SUBJECT: Forwards draft responses to Reactor Sys Branch questions which will be discussed during 800821 meeting. Responses to Questions 211.201, 211.266, 211.267, 211.268 & 211.269 will be provided on 800821. *See Report*

SUSQUEHANNA STEAM ELECTRIC STATION  
RESPONSES TO REACTOR SYSTEMS BRANCH QUESTIONS  
ER 100450 FILE 841-2  
PLA 518

Attached are PP&L's draft responses to the Reactor Systems Branch questions which will be discussed during the meeting on August 21, 1980.

**FIGURE 9.2-2**

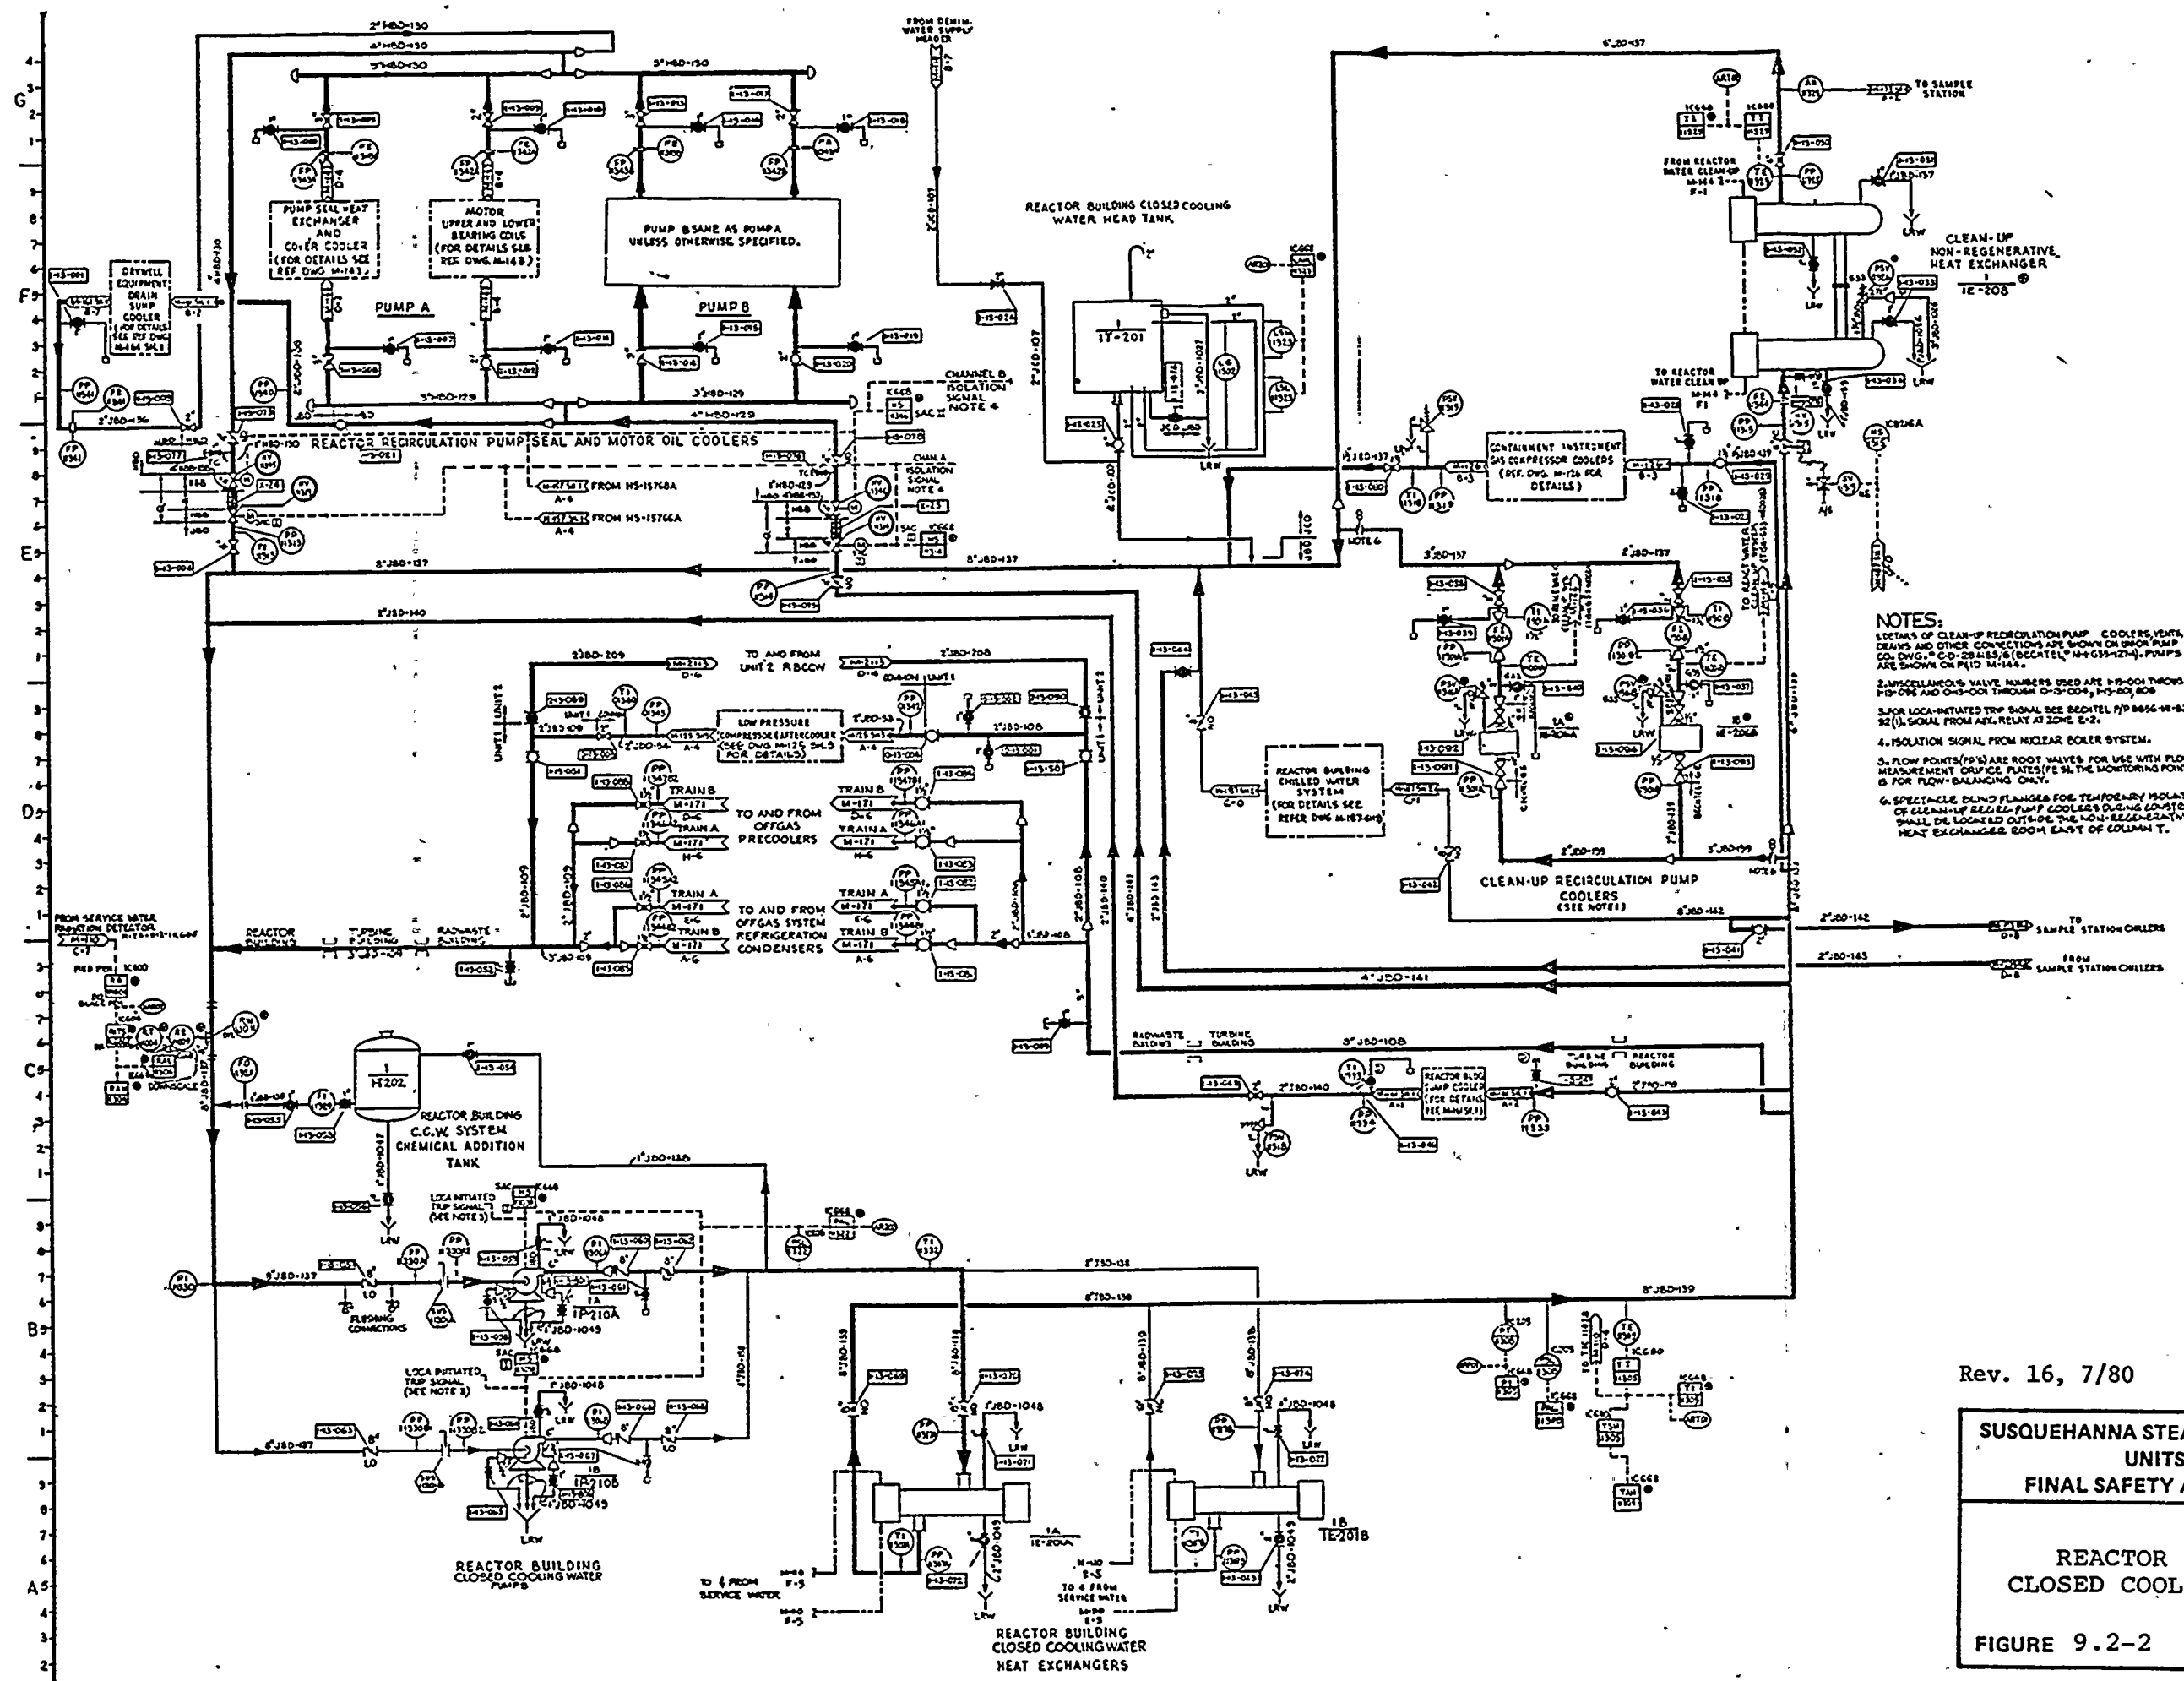
Table 3.2-1, page 10, lists piping and valves forming a part of containment boundary of the Reactor Building Closed Cooling Water System as Quality Group B, Safety Class 2, Seismic Category I. Penetration of primary containment for this piping is not shown on any of the relevant P & I Diagrams. Show the above piping and valves on appropriate P & I Diagrams and indicate the classification of this piping.

Piping and valves forming a part of containment boundary of the reactor building closed cooling water system are shown on the revised FSAR Figure 9.2-2. Penetration of primary containment is through the 4"-HBB-157 and 4"-HBB-158 lines which are shown on revised Figure 9.2-2.

FIGURE 5.2-5

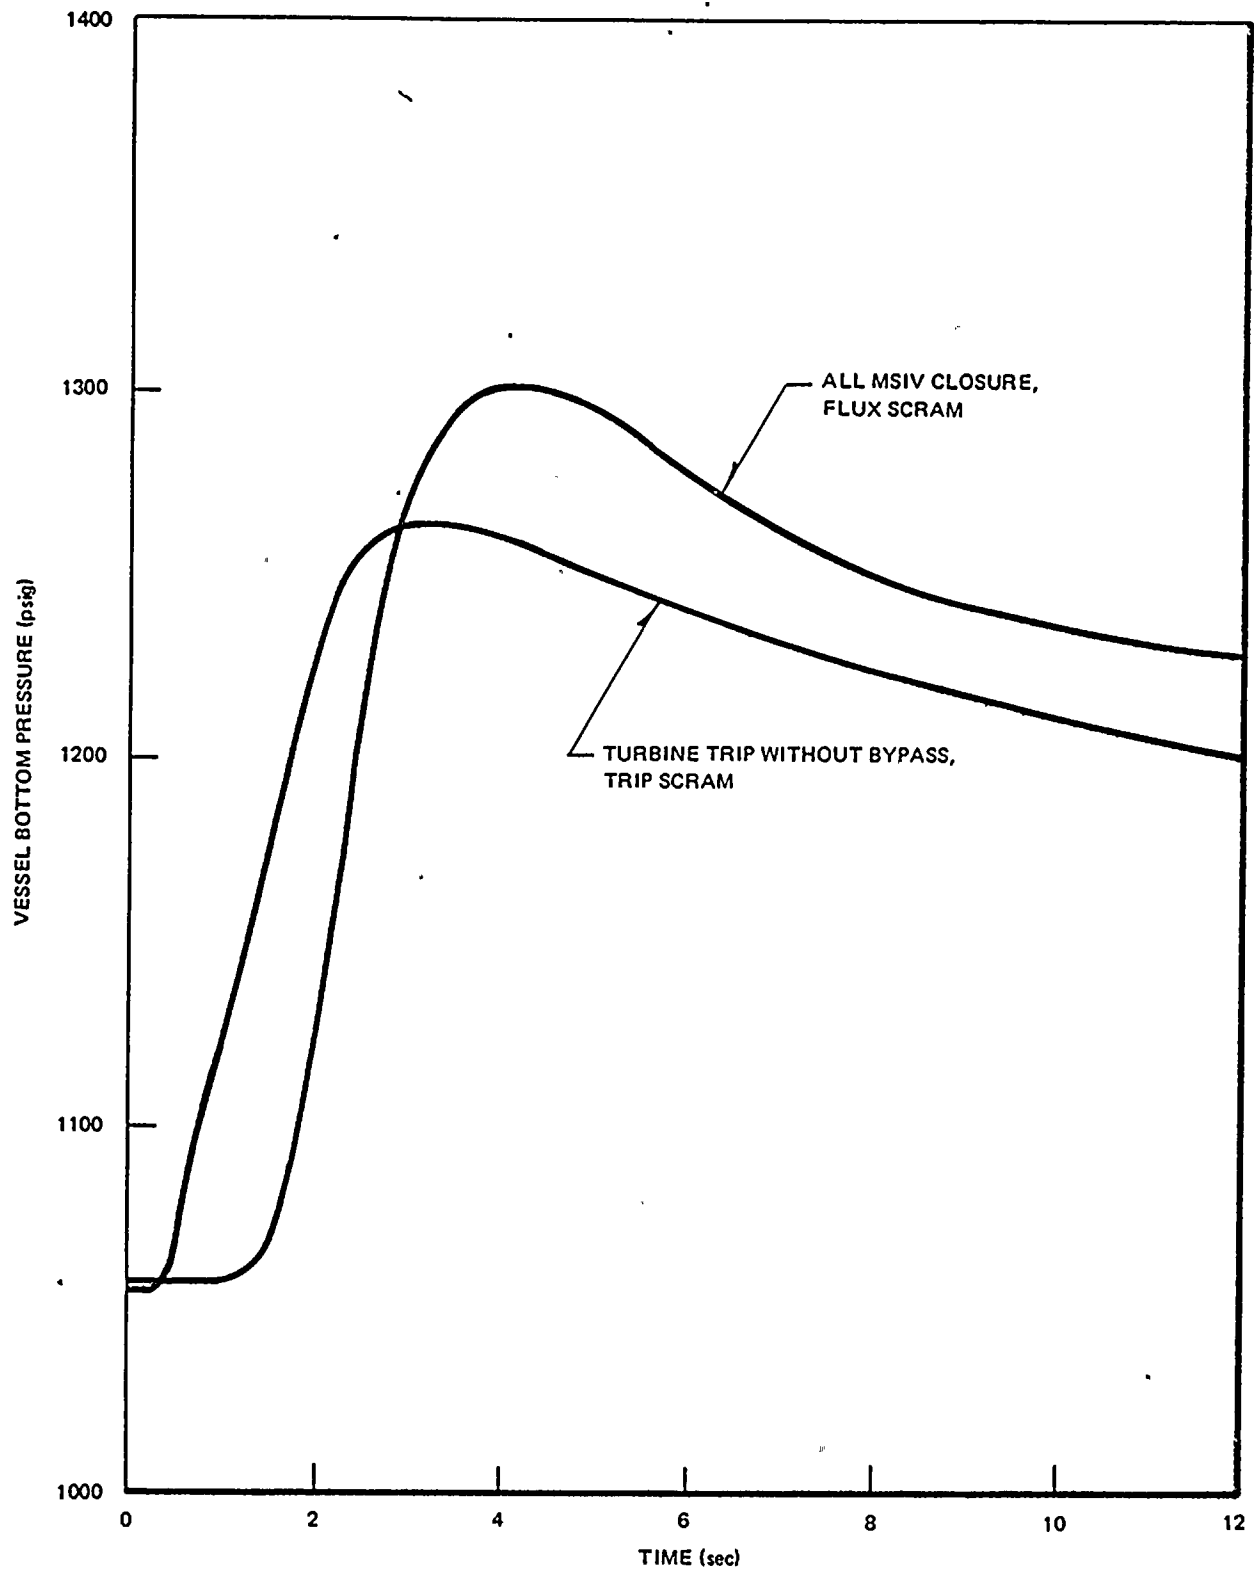
Were the curves in Figure 5.2-5 which shows the pressure at the vessel bottom versus time for the MISIV transients based on 105% of rated steam flow? In not, provide these curves.

The curves in Figure 5.2-5 are based on 105% NBR steam flow.
